Questions on PLN2019-00368 for CDRC hearing 5/14/2020:

Landscaping: March Design

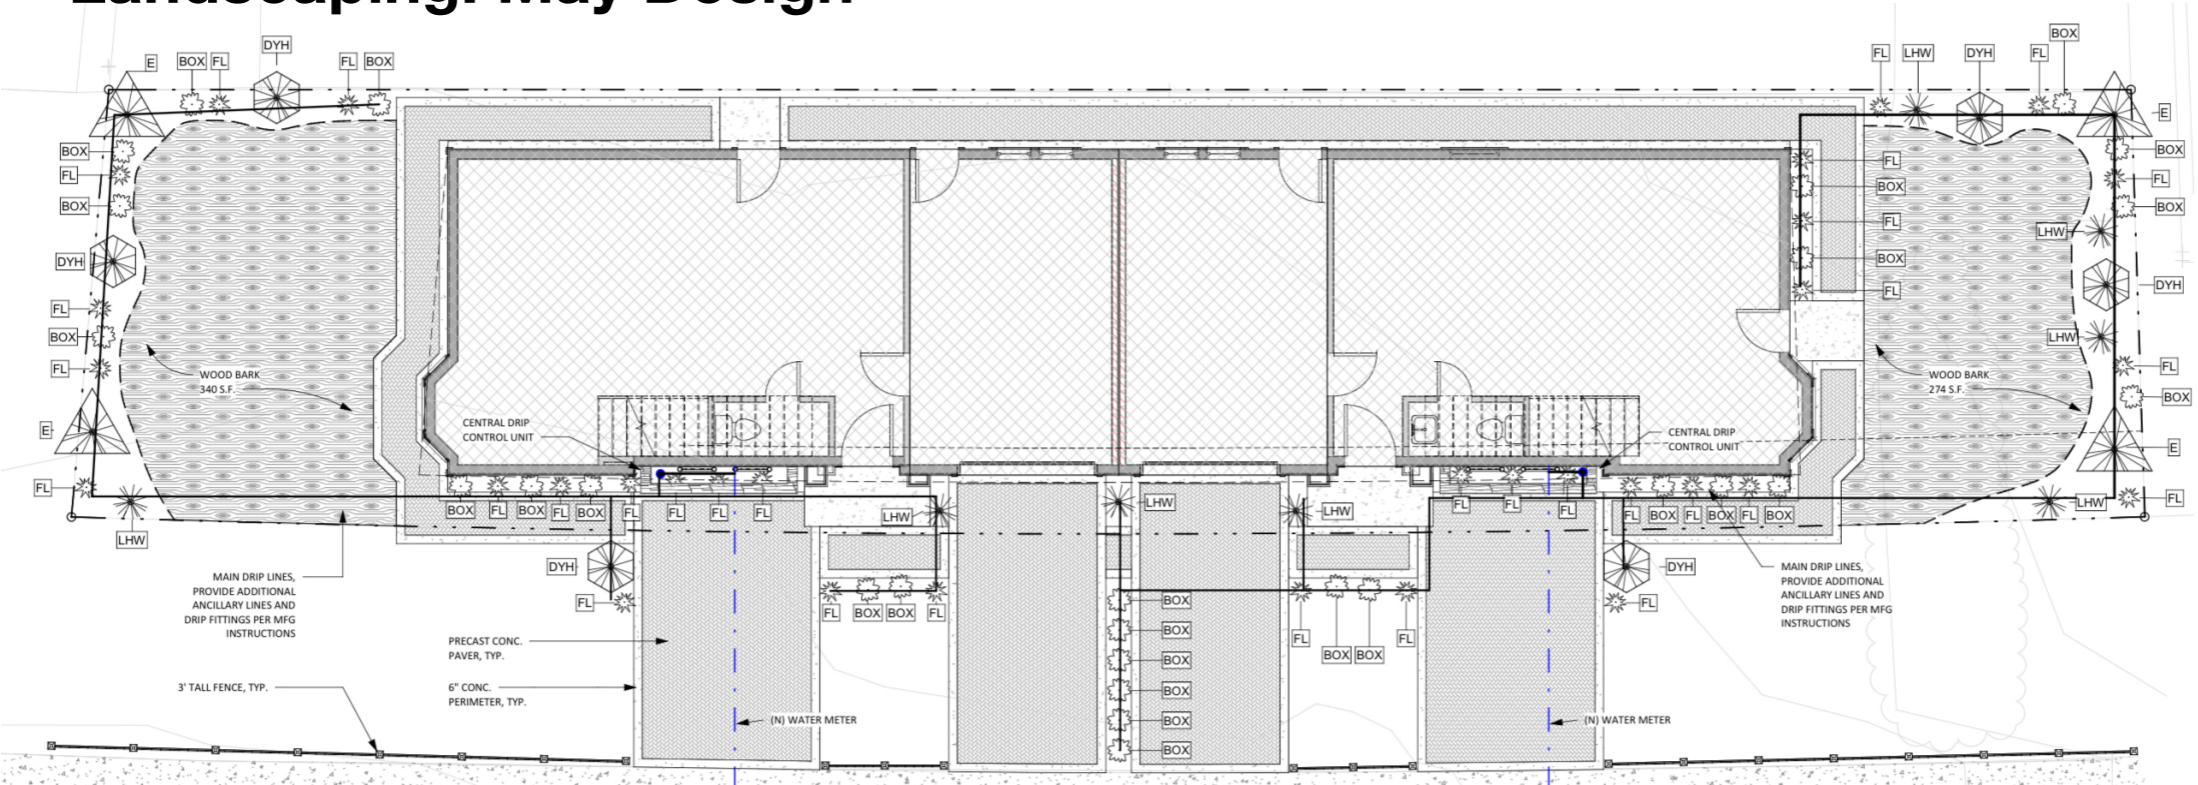
- The GSC made finding for granting variance for sewer conditioned on the amount of impervious area to be lessened from 19.01% to 10% (p 6). How was that accomplished in the new design? The plans March and May look identical, p 2 The paving changed from 134 to 88.2 (if 882 is a misprint), and the walkway coverage went from 447.53 to 61 SF, how is this illustrated? Is it pervious or impervious paving?
- What is the landscaping for the 'red areas', p 4?

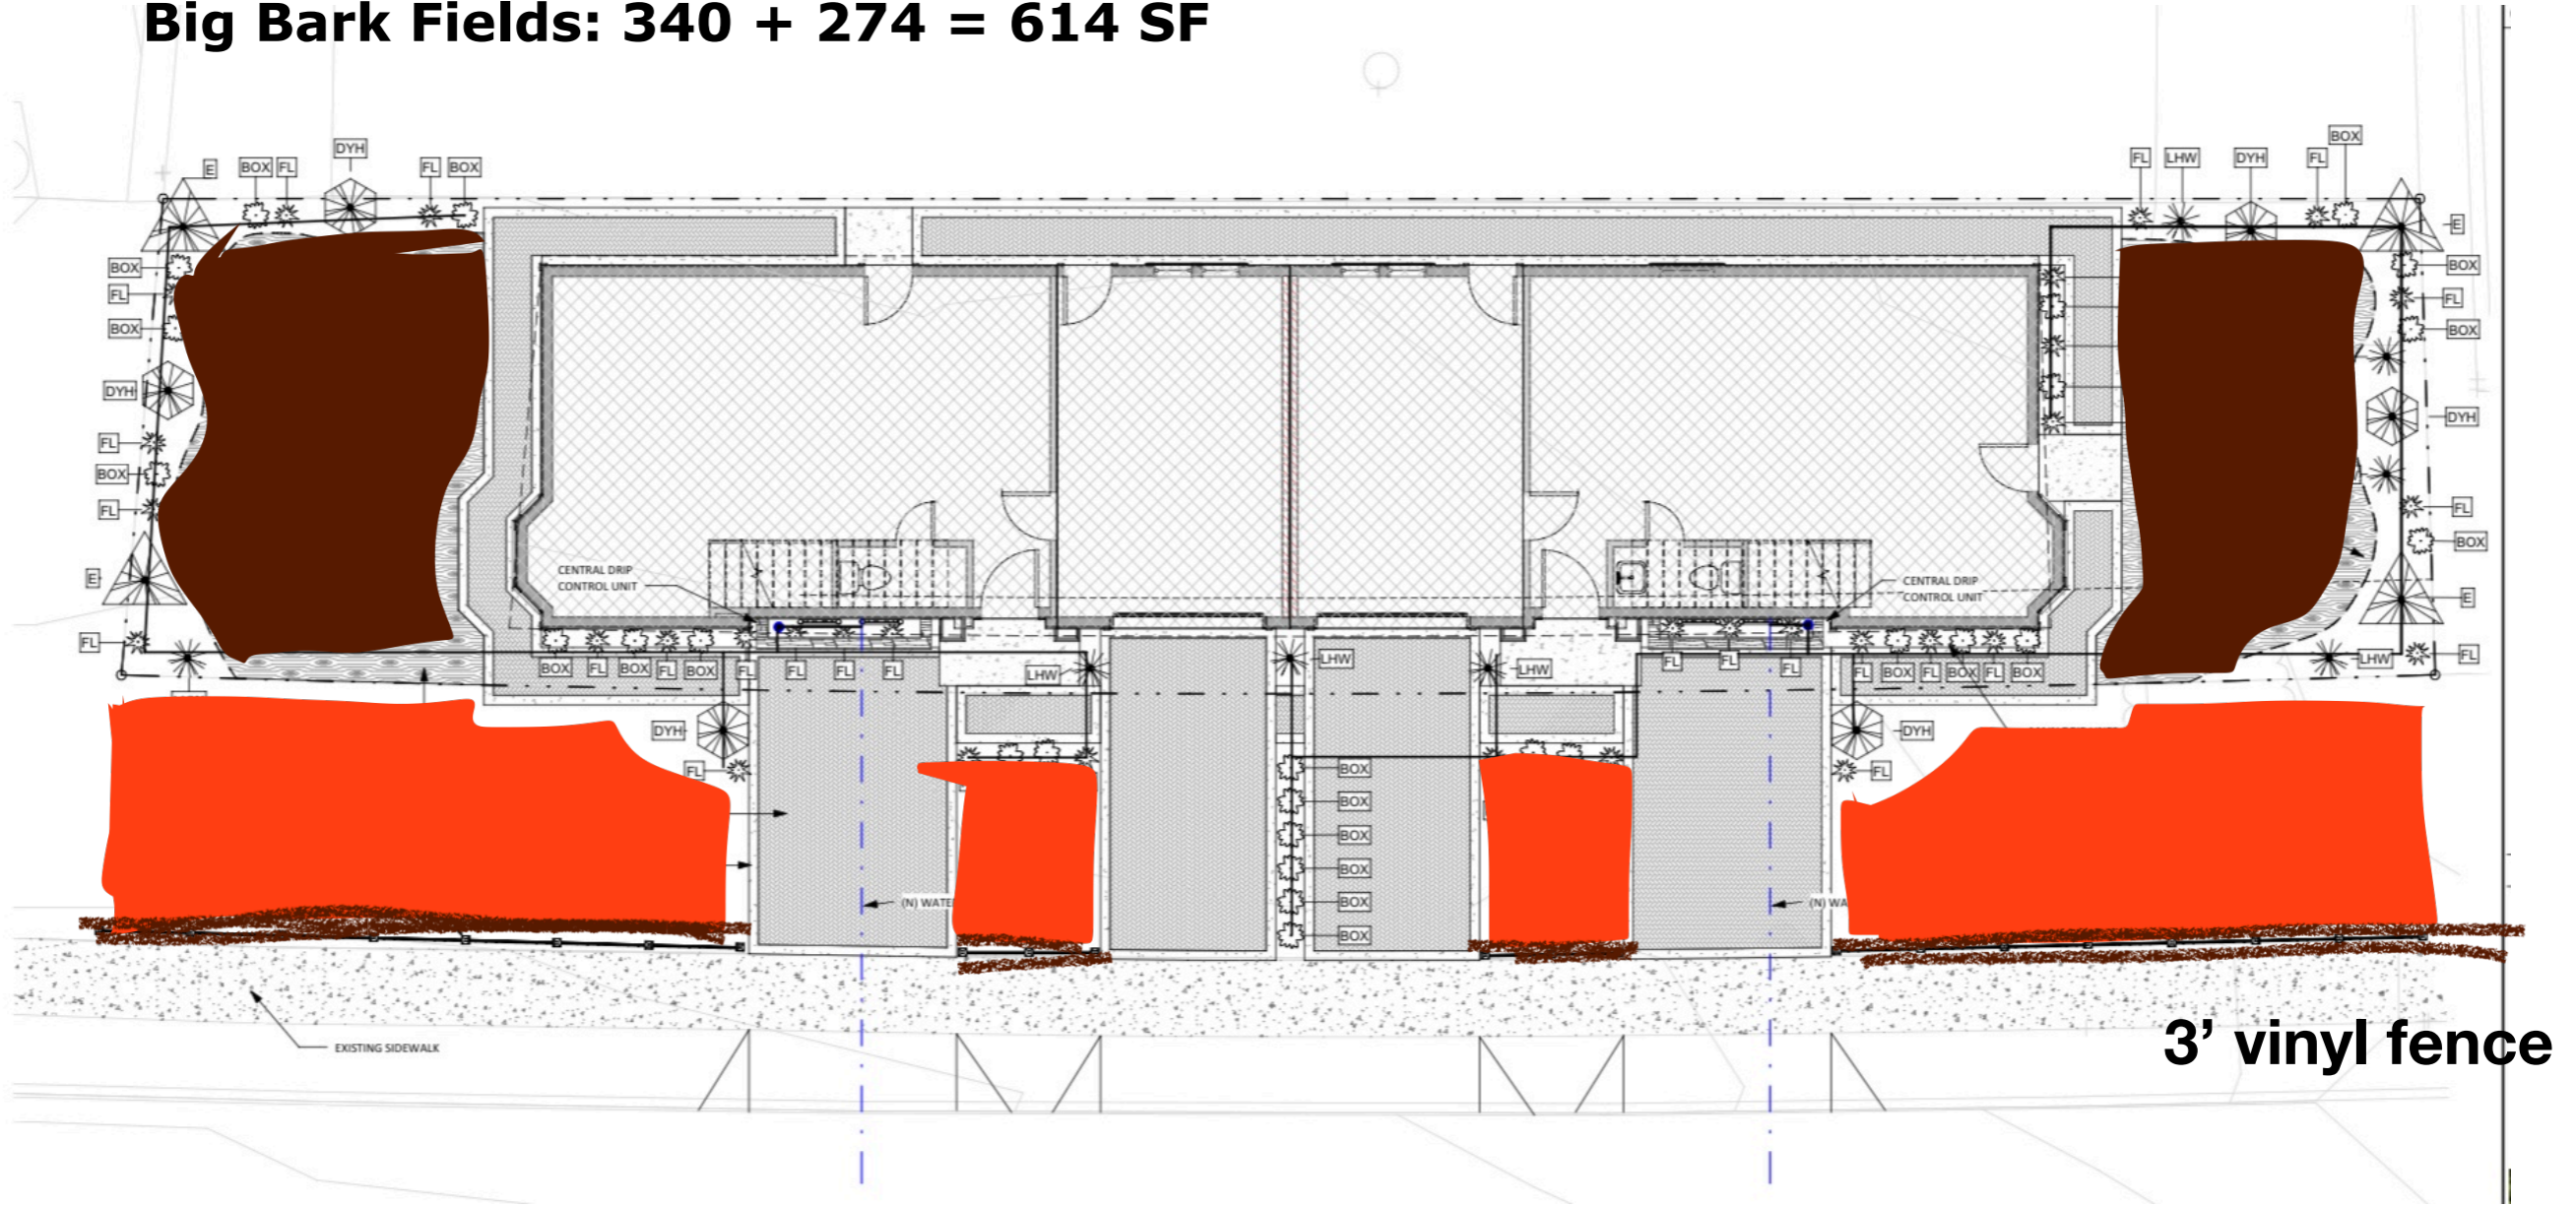
3,290 SF at CDRC in March 2020 — — —> 3,056 SF at CDRC May 2020
3,020 SF according to GCS surveyor. (when presented to them to parcel size was 3,056 in Nov 2019.)

Needs 2 covered parking spots per unit? Regulations?

See GSC:
only 10% impervious surface allowed. The 19.02% needed to be lowered to 10%, instead it increased to 29.1%

Bark = 614 SF = 20.1%

882/ 3056= 28.9%

88.2/3056= 2.89%

Missing landscaping
Big Bark Fields: 340 + 274 = 614 SF

PARKING VARIANCE? 4 Driveways? What size? 12 x 18?

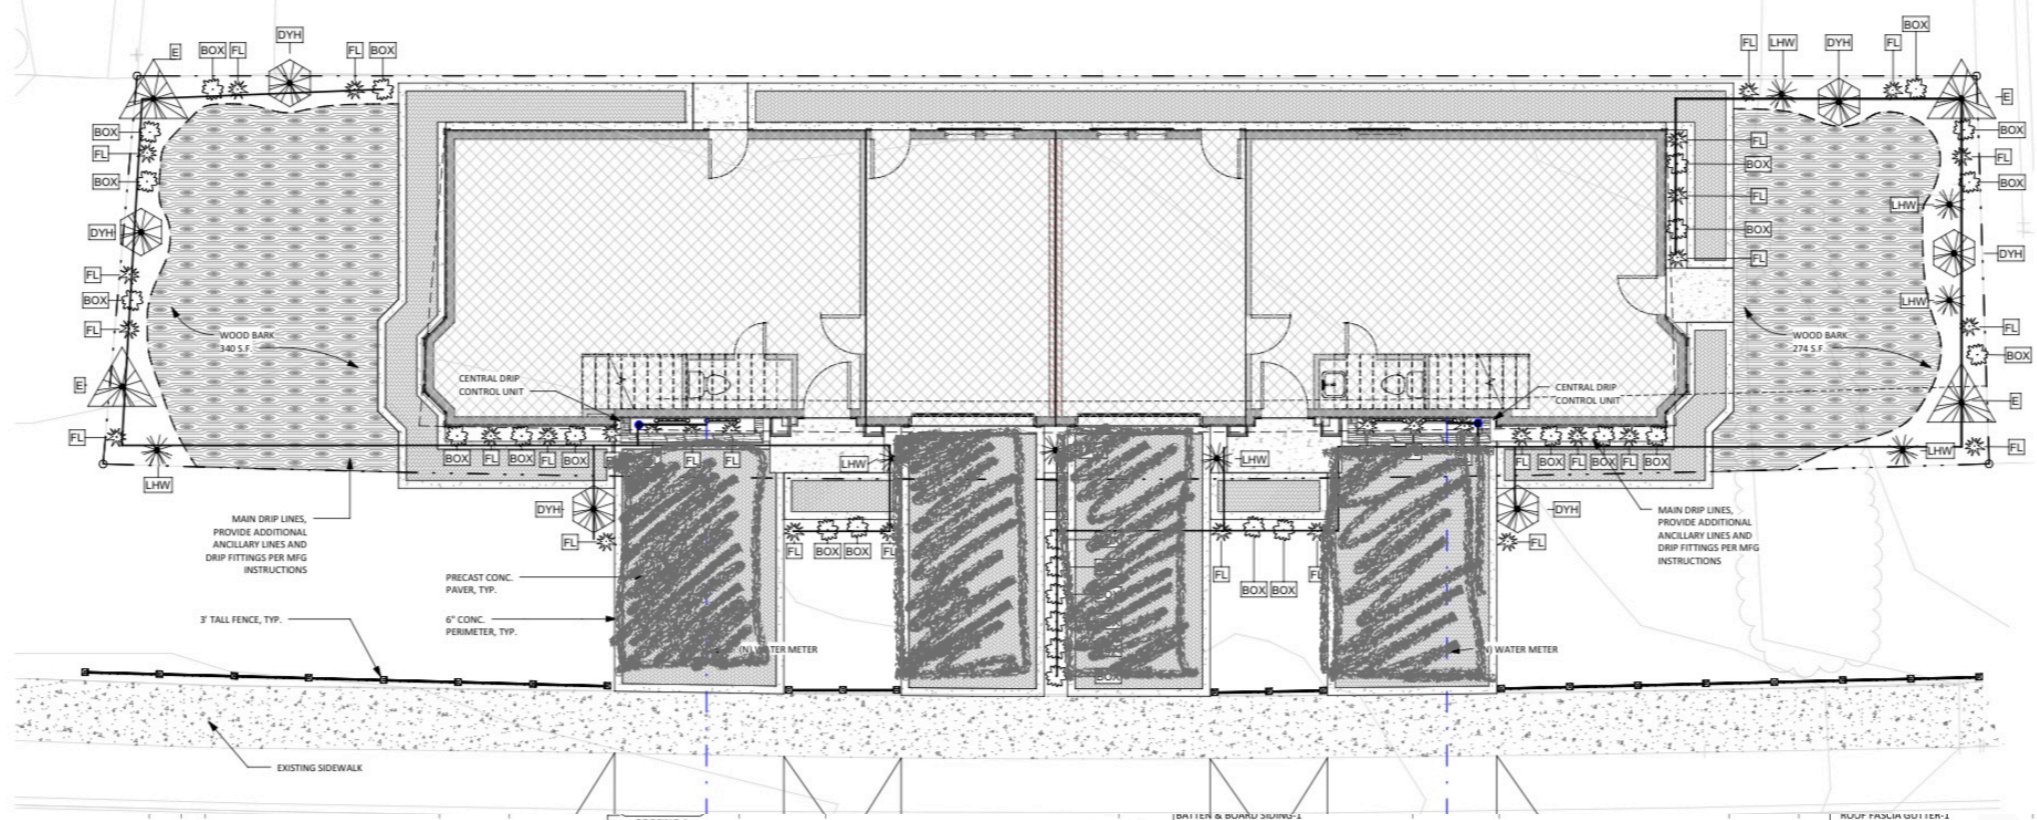
- It looks like 4 driveways on the plan (p 4). Because of the 3' setback (instead of 10') cars parked in the driveways, will have their 'butts' right up to the sidewalk, making it unsightly (5).
- The architect plan states '2 required, 2 proposed'. Isn't it 2 covered parking spots per 'over 2 bedrooms', which would be 2 required per unit, total of 4? So another variance is needed for this? The California Coastal Commission (CCC) asked for the regulations regarding findings for parking exceptions according to project planner notes. What are the regulations regarding parking exceptions?
